Reference: 18.555r03v04

Re: 1B Bolingbroke Parade, Fairlight – Alterations and Additions
Response to Request for Information

We refer to the proposed alterations and additions to the existing Manly Boatshed. TRAFFIX has been forwarded the submission prepared by McLaren Traffic Engineering on behalf of some residents (reference: 200783.01FA) and now provides the following response to each item raised:

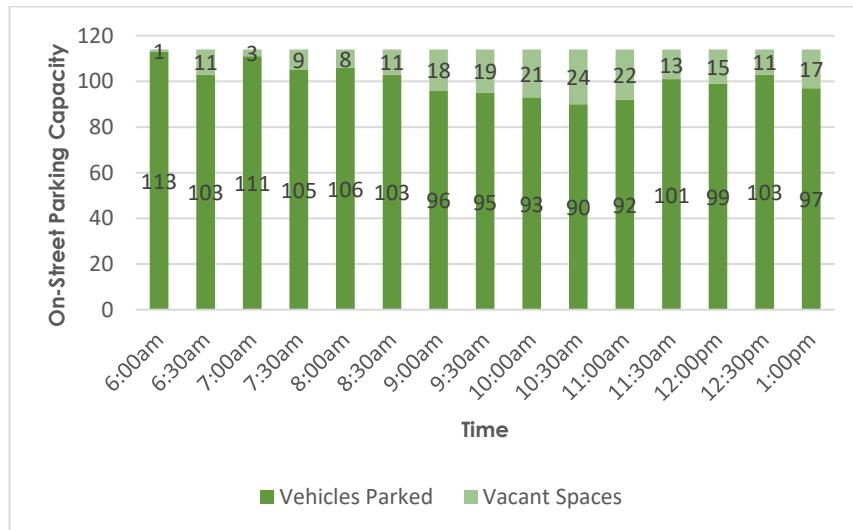
"The TIA does not provide a parking survey of nearby parking supply nor changes in availability through the peak operating times of the development. It is unknown the number of spaces available within the vicinity of site and how any of those spaces are impacted by duration of stay restrictions. The TIA makes a qualitative assessment based on some "a review of aerial photography over multiple days" and then proceeds to neither list which days of the week, which periods of the year or which times of times those images were taken. In doing so the TIA presents a baseless analysis of the potential impacts of the existing development and proper function of the surrounding parking environment. This firm has conducted a similar aerial photography desktop review and as shown in Figure 1, on the 26th September 2020 there was zero spare parking available within 200m walking distance of the site and that additionally there are several cars parking over the verge in driveways such that more than 100% of the public parking is being used. This is an obvious difference to that existing situation described in the TIA and leads to a low level of credibility of the TIA. Additional days of imagery are provided in Annexure A."

Nevertheless, in order to address these concerns, on-street parking surveys were conducted on Saturday 7 November 2020 and Tuesday 10 November 2020, between 6am and 1pm at 30-minute intervals. The survey dates enjoyed fine weather and were considered satisfactory for the parking survey, representing a typical November day. This survey comprised the following streets which were of particular concern to local residents:

- Bolingbroke Parade, between Lauderdale Avenue and Manly Boatshed (47 spaces)
- Fairlight Crescent, between Bolingbroke Parade and Lauderdale Avenue (62 spaces)
- Arlington Drive, between Fairlight Crescent and Lauderdale Avenue (5 spaces)

TOTAL 114 spaces
